ADDRESS: 602 S FRONT ST

Proposal: Construct shed dormer and replace front windows

Review Requested: Final Review

History: ca. 1795; James Henderson House

Figure 2. Contemporary image of 602 S Front St. Source: Applicant.

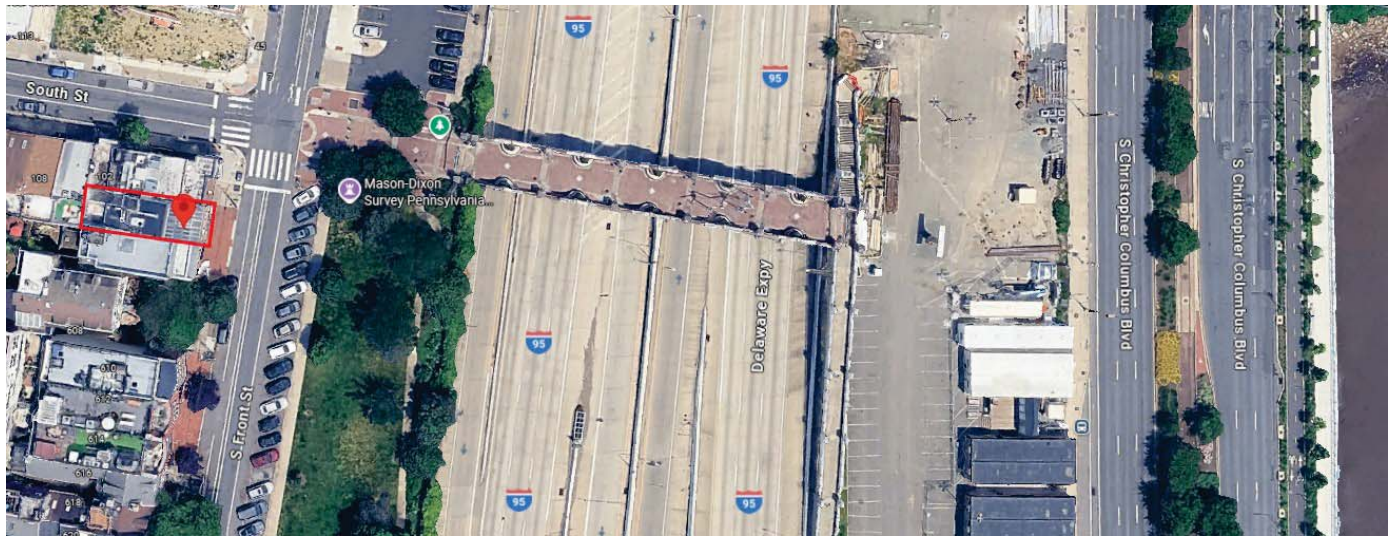
- Although the existing front dormer is clad in glass, it maintains its historic form and proportions. Removal of the front dormer does not meet Standard 2.

- The proposed shed dormer would be highly visible, and the proposed design and materials are incompatible with the late eighteenth-century house. Therefore, it does not meet Standard 9.

- The four front windows on the second and third floor are not original and can be replaced in kind with new double-hung wood windows. An in-kind replacement would meet Standard 9. The current proposal to replace the historically accurate windows with casement windows does not meet Standard 9.

STAFF RECOMMENDATION: Denial, pursuant to Standards 2 and 9.
